# THE ILLUSION OF ENVIRONMENTAL PROTECTION

## PERMITTING LONGWALL COAL MINES IN PENNSYLVANIA

This report provides an in-depth, independent review of the Foundation Mine permit application and its review by the CDMO. This analysis provides a unique insight into the current regulatory review process involving longwall coal mines in Pennsylvania. It examines how well the current review process implements the laws and regulations adopted to protect environmental resources from coal extraction activities. This report uses the Foundation Mine application as a case study to determine how successfully the Pennsylvania Department of Environmental Protection requires an applicant to inventory resources at risk from a proposed longwall mine operation, predict potential impacts, and identify measures to minimize and address likely impacts in accordance with existing laws and regulatory requirements. The report also examines the adequacy and effectiveness of the State's mine permit application forms, technical guidance, and overall process in eliciting the information necessary to evaluate potential impacts and to demonstrate compliance with applicable laws and regulations.

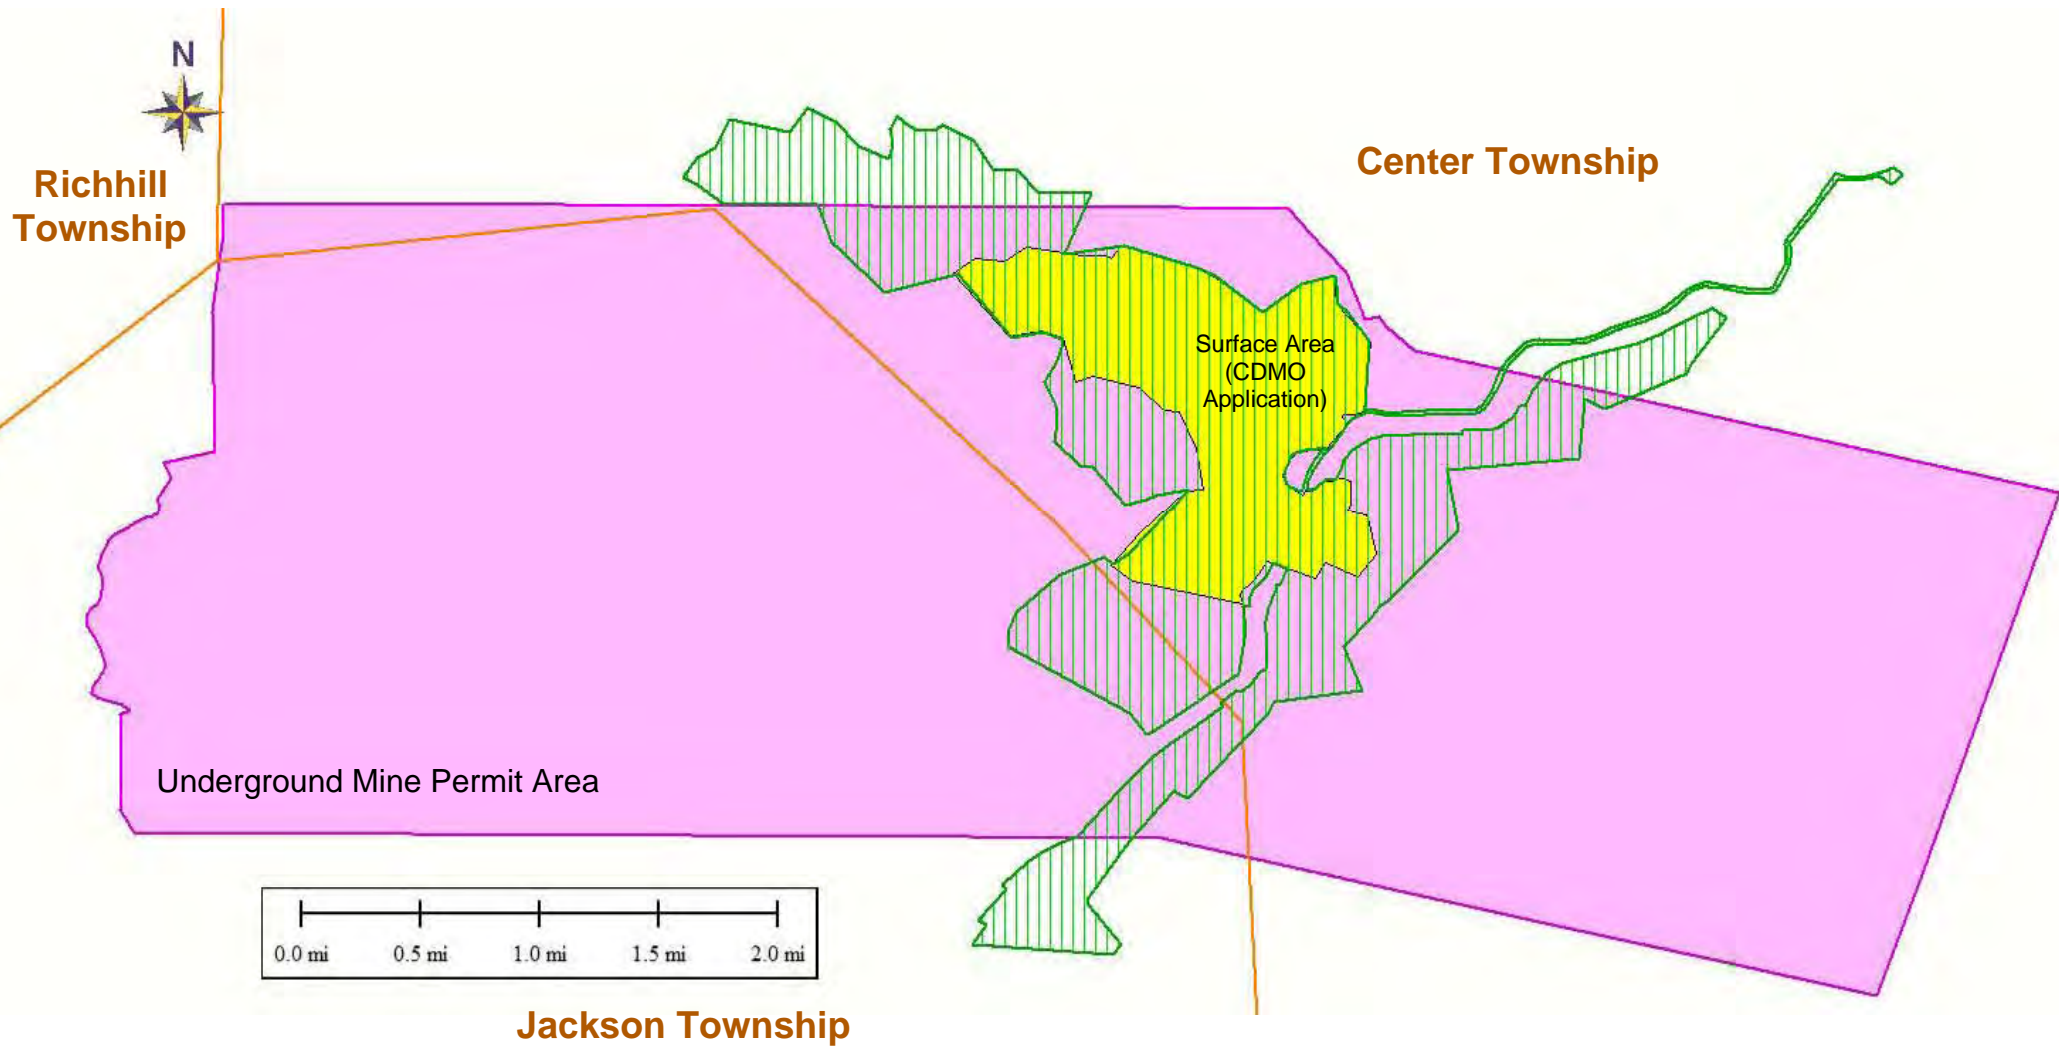
Given the high probability of damage to its industrial facilities by subsidence, longwall extraction generally is not conducted beneath a mine's surface facilities. The layout of longwall panels presumably would need to be revised significantly from what was proposed in the 2010 State mine application if the additional surface activities on 1,225 acres were to be constructed as proposed in the 404 permit application.

According to Module 15 in the State underground mine permit application, the activities proposed in State and federal applications must be consistent. Form 15A (in Module 15) states that *"If the scope of activities described under the federal permit application differs from the scope of activities described under the state permit application, attach a copy of the federal permit application"*. The (undated) Form 15A for Foundation Mine noted that a Corps Individual Permit was "pending", although that Corps 404 application apparently was not *submitted* until more than a year after the 2010 State mine application was submitted. Form 15A states that any substantial

revisions per a federal application must be provided to the District Mining Office. No copy of the federal permit application was found in the CDMO files provided during our November 2011 or March 2013 file reviews. Reportedly, the applicant did provide a complete copy of the Corps 404 application to the CDMO, but the CDMO promptly *returned* it, explaining that it was of no interest to the State’s reviewers.

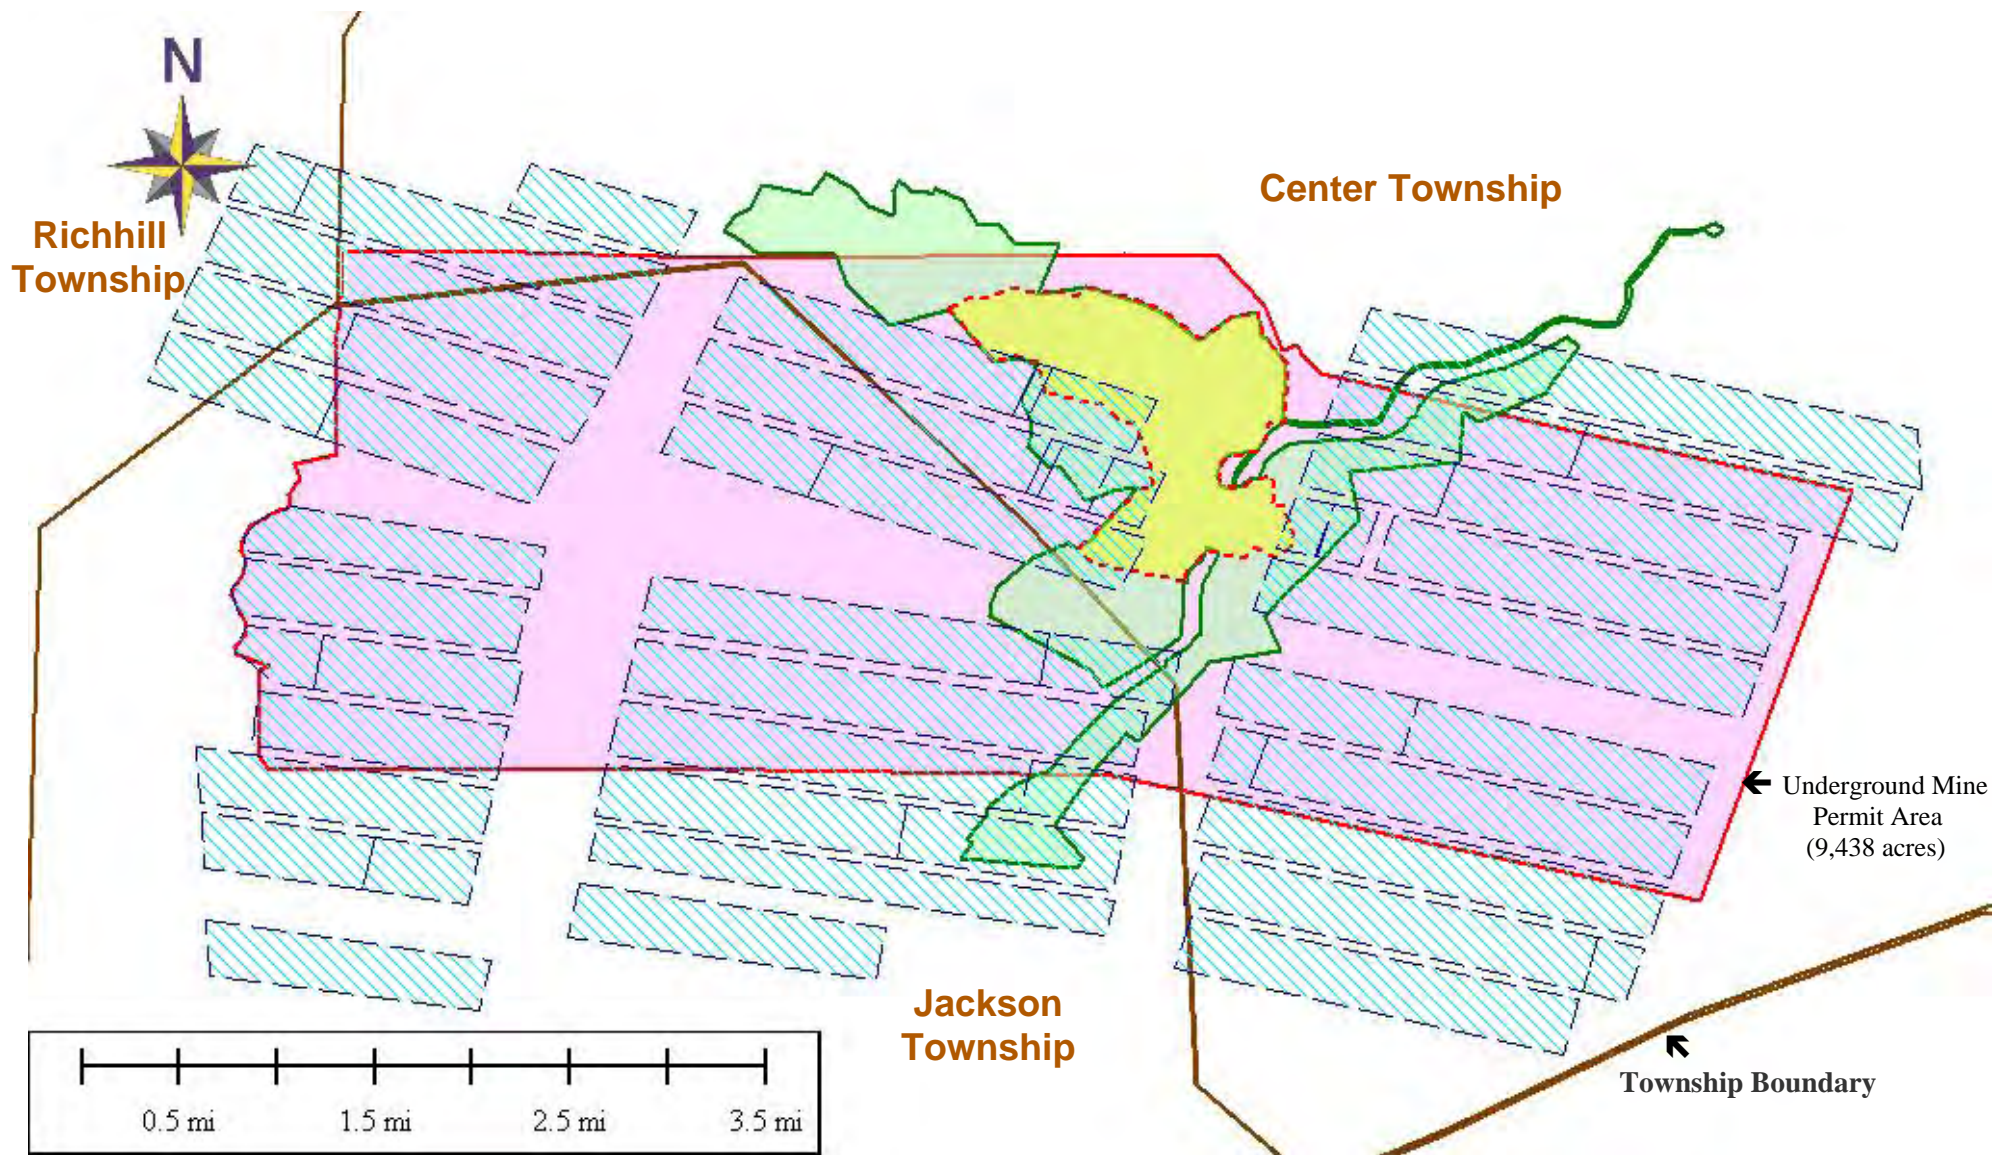
A close examination of some of the maps in both the State underground mine application and the federal 404 application identified proposed mining that extended far outside the 9,438-acre area (**Figure 4**). Some maps identified areas designated for future mining (e.g., “Years 21 to 25” on Drawing 22.4). It is unacceptable that an application for a new mine did not clearly identify the maximum ultimate extent of the proposed operation (relative to unmined resources or the applicant’s mineral holdings), even if all of the specific details of future expansions were not known at the outset. Without full disclosure of what was to be done and where, and over what period of time, the reviewing agencies (much less members of the public who will be directly and indirectly affected) cannot not understand the project well enough to make an informed decision regarding its relative benefits and impacts.

**Recommendation:** The exact full extent of any proposed underground mine, as well as the approximate extent and number of its potential future expansions, must be made clear.

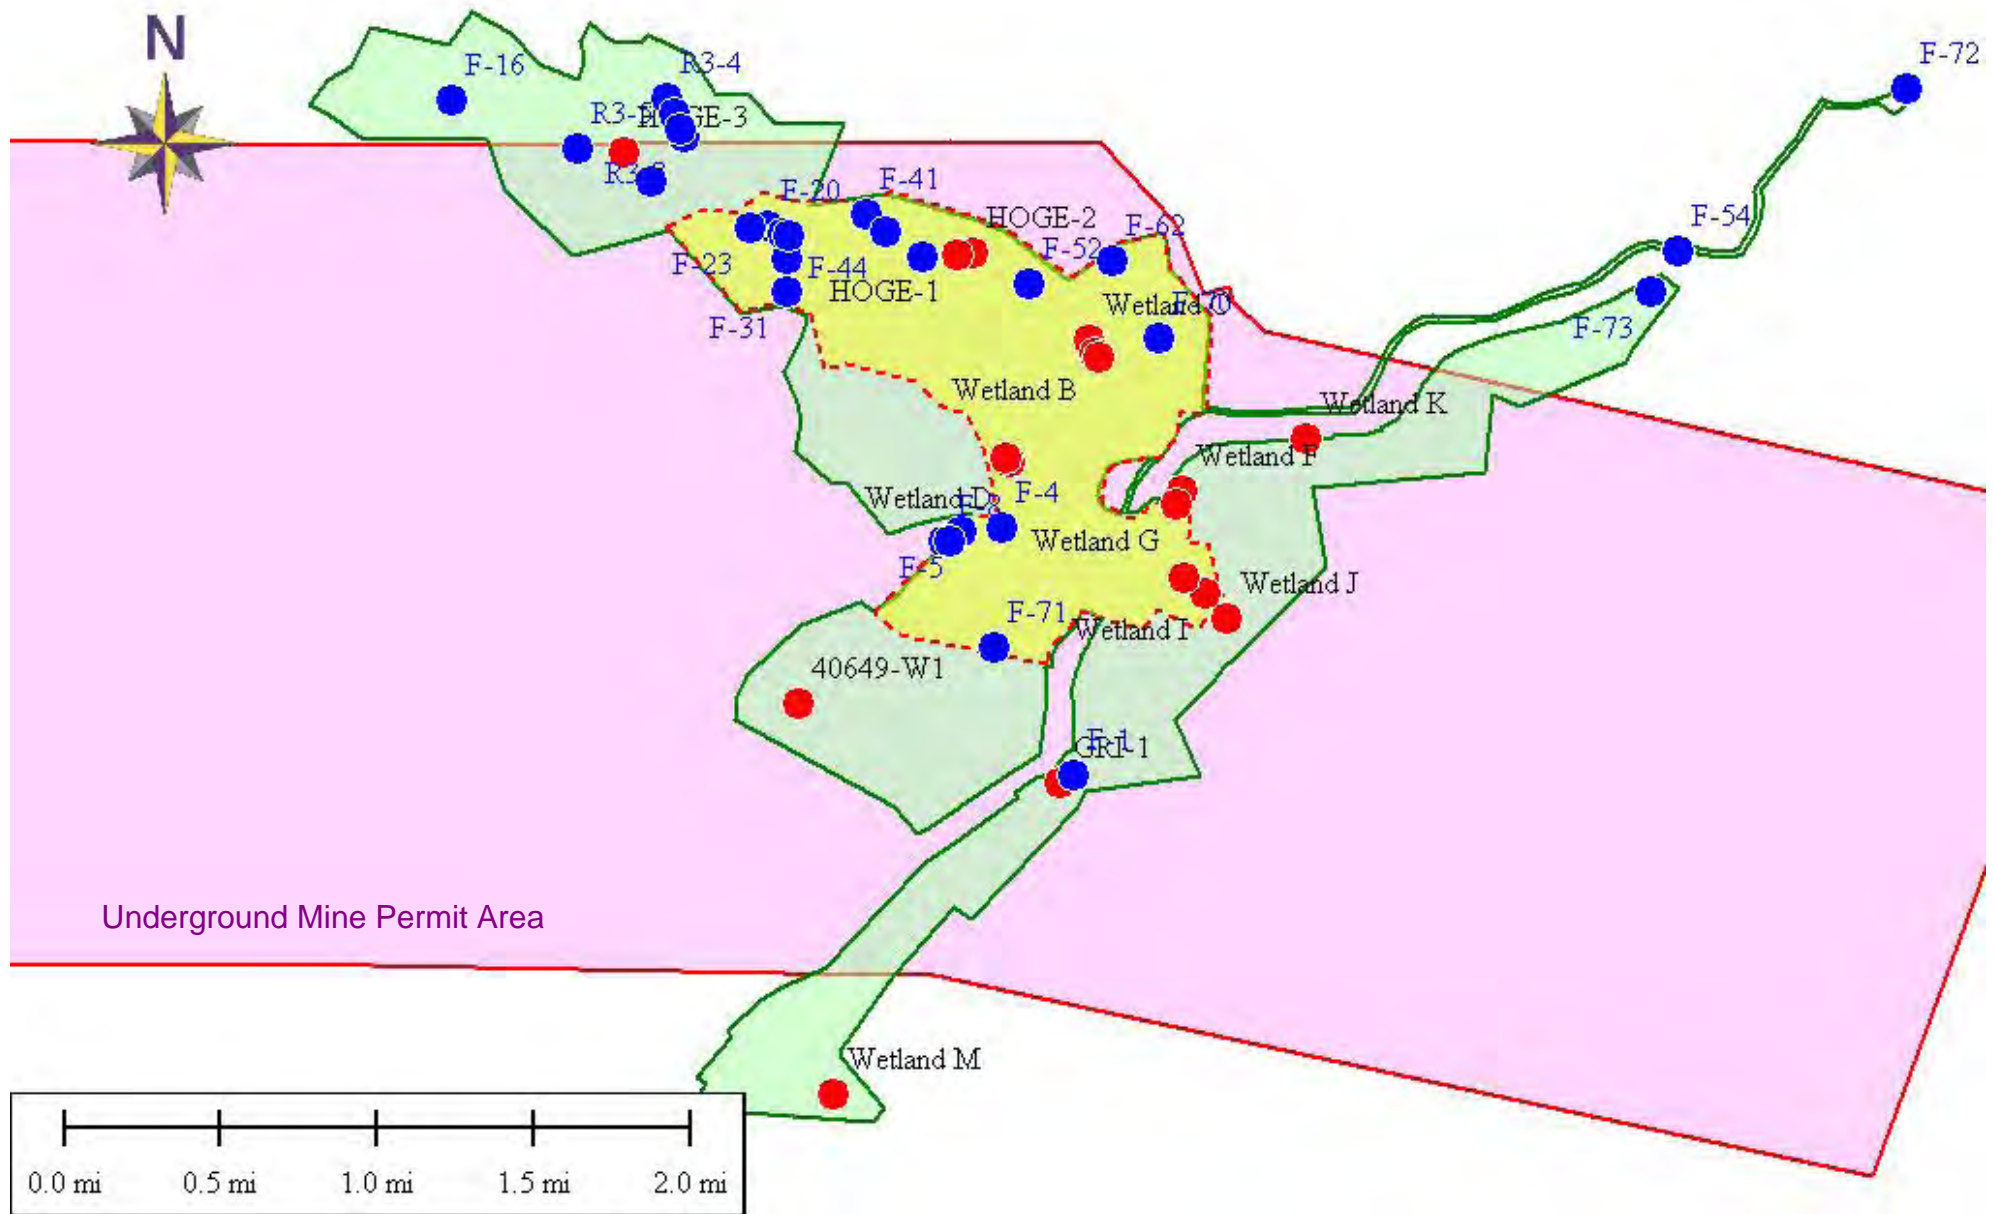
The 28 additional wetlands identified by the Corps but not by the applicant within the 1,867-acre area represent more than half of the final total of 44 wetlands there (**Figure 5**). Such a discrepancy clearly illustrates the necessity and importance of having a Corps JD performed in conjunction with every coal mine application if all wetlands are to be identified.

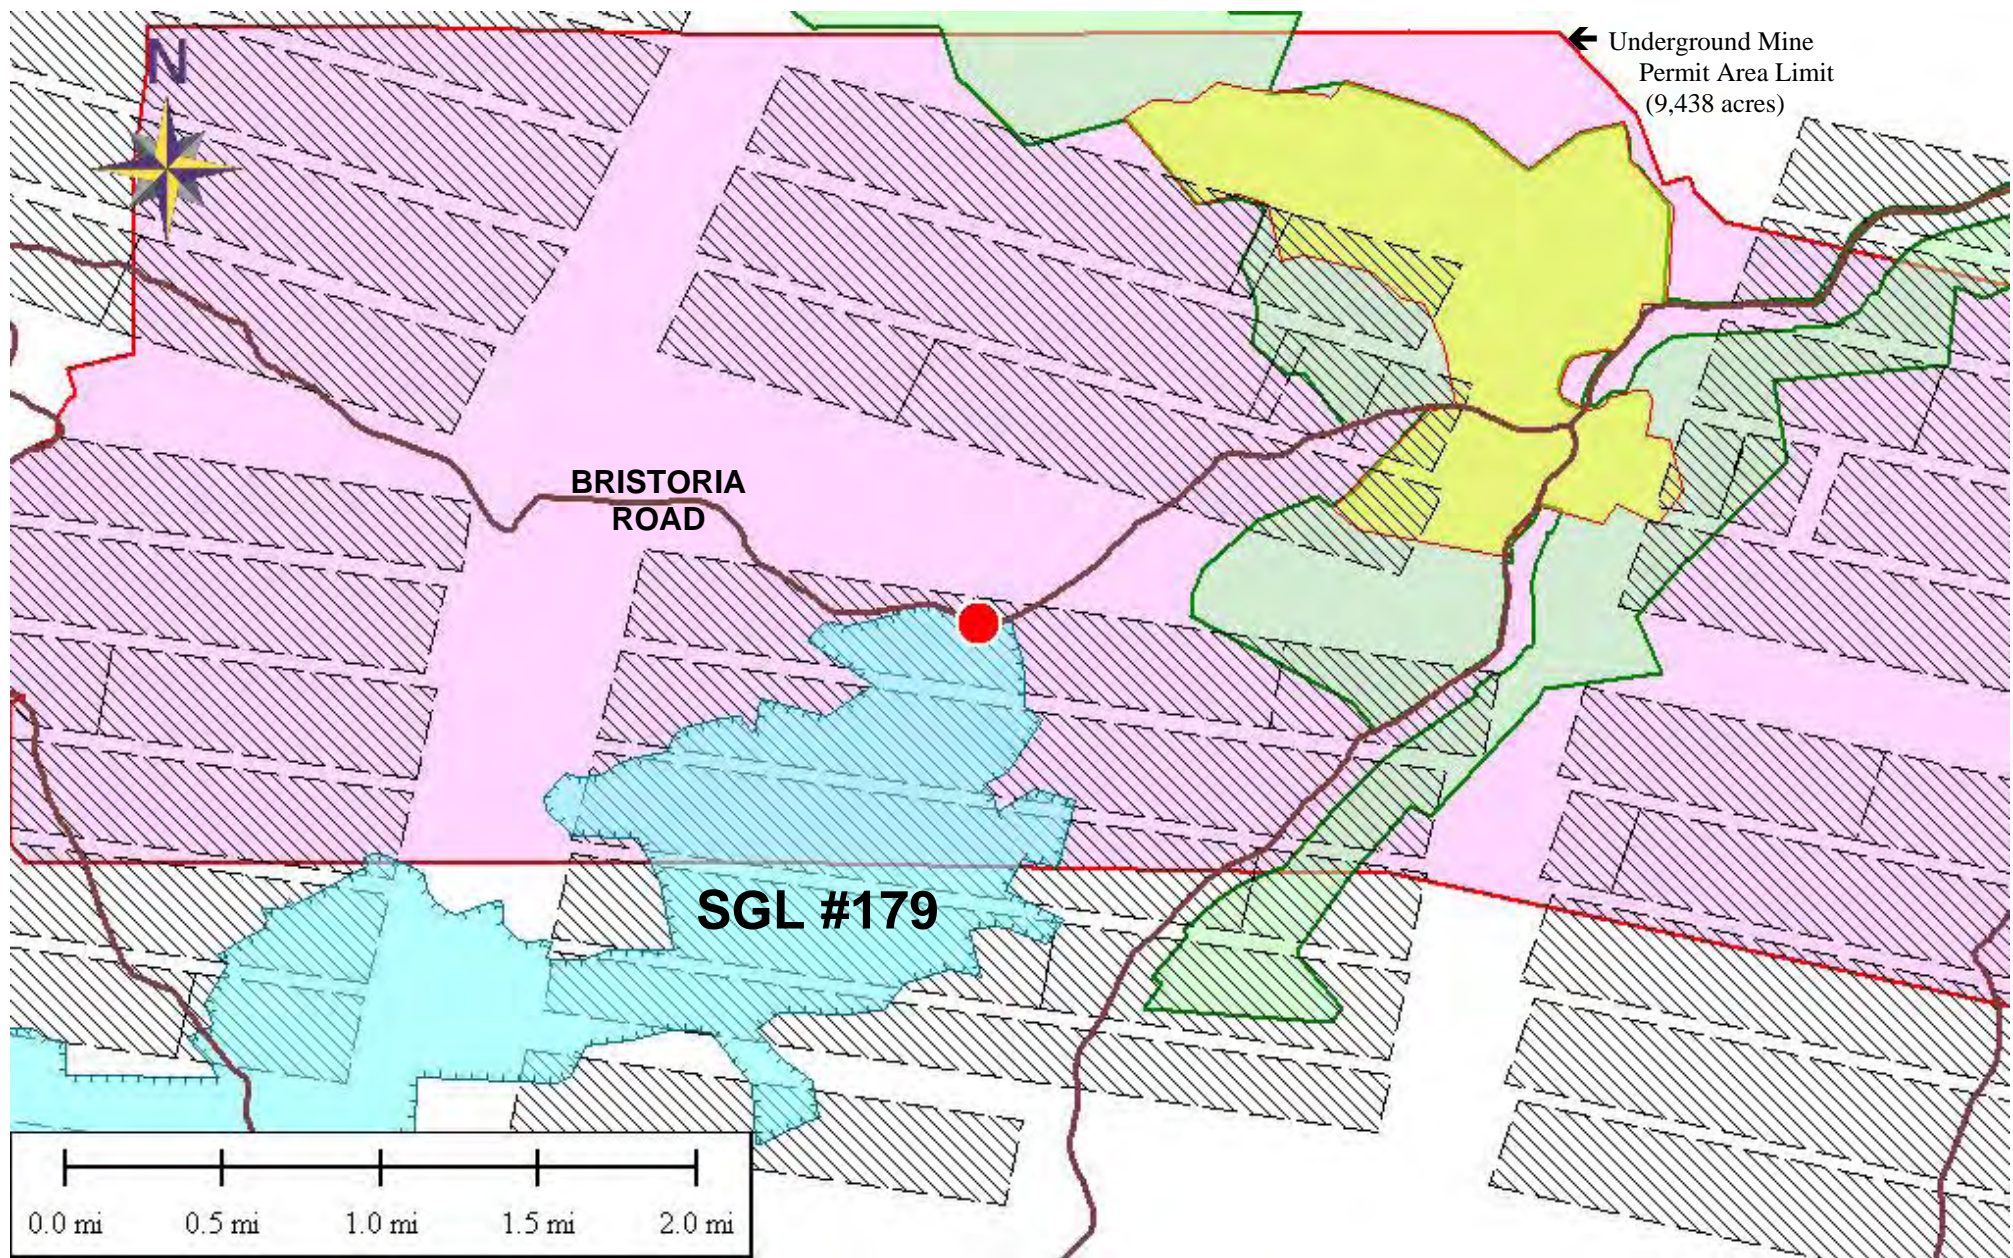
of Foundation Mine outside of the surface activities area. Numerous additional wetlands were observed (see **Figure 7**), wetlands that were not delineated in this permit application or reviewed/confirmed by Corps JD. One wetland of significant size (approximately 5 acres) was observed along the south side of Bristoria Road, within State Game Lands #179 (see **Figures 6a** and **6b**).
